The Secretary  
NSW Department of Planning, Industry and Environment

I refer to the Department's below email of 4 May 2021 regarding the notice of exhibition of the Environmental Impact Statement (EIS) for State Significant Development SSD-8845345 Budawang School for Specific Purposes for 'Construction and operation of the Budawang School for Specific Purposes' at 17 Croobyar Road, Milton (Lot 200 DP 1192140) in the Shoalhaven City Council Local Government Area (LGA). Submissions need to be made to the Department by 2 June 2021.

**Subject:** Notice of Exhibition - Budawang School for Specific Purposes (SSD-8845345) - Endeavour Energy

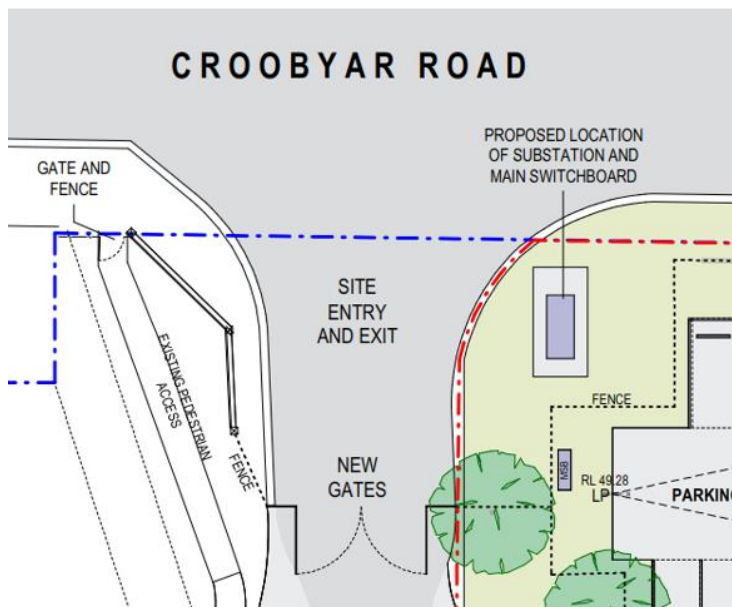
The proposed padmount substation is shown in the following extract of the Site Plan from the Architectural Drawings.

From Endeavour Energy's perspective the fact that provision is being made for a padmount substation is a positive. Endeavour Energy's general requirements is for a padmount substation to be at ground level and have direct access from a public street (unless provided with appropriate easements for the associated underground cables and right of access).

#### A4.3 - Padmount easements and clearances

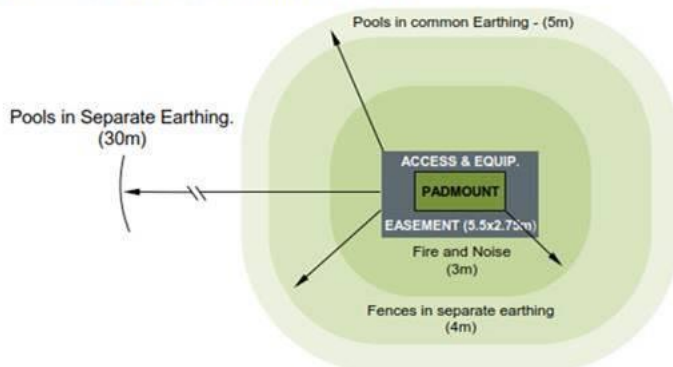
As shown in the following extract of Endeavour Energy's Mains Design Instruction MDI 0044 'Easements and Property Tenure Rights', Figure A4.3 'Padmount easements and clearances', padmount substations require:

- Easement with a minimum size of 2.75 x 5.5 metres (single transformer).
- Restriction for fire rating which usually extends 3 metres horizontally from the base of the substation footing / plinth and 6 metres vertically from the same point.
- Restriction for swimming pools which extends 5 metres from the easement.

The easement should not cross property boundaries but the restriction/s may affect any adjoining property provided they are able to be registered on the title to that property. In addition the following matters also need to be considered in regard to the fire restriction:

- Personnel access doors and fire exit doors to a building are not permitted within the fire restriction area.
- Gas mains/pipes shall not pass through the fire restriction area.
- A 10 metre clearance distance shall be maintained between substation and fire hydrants, booster valves, and the like in accordance with AS2419.1 'Fire hydrant installations System design, installation and commissioning' as updated from time to time.
- Consideration should be provided to the appropriateness of the landscaping relative to the fire restriction for the substation. Any landscaping that potentially could transfer / provide connectivity for flame or radiant heat from a fire in the substation to a dwelling or building should be avoided.
- The storage of and / or use of flammable, combustible, corrosive or explosive material within the fire restriction should be avoided.
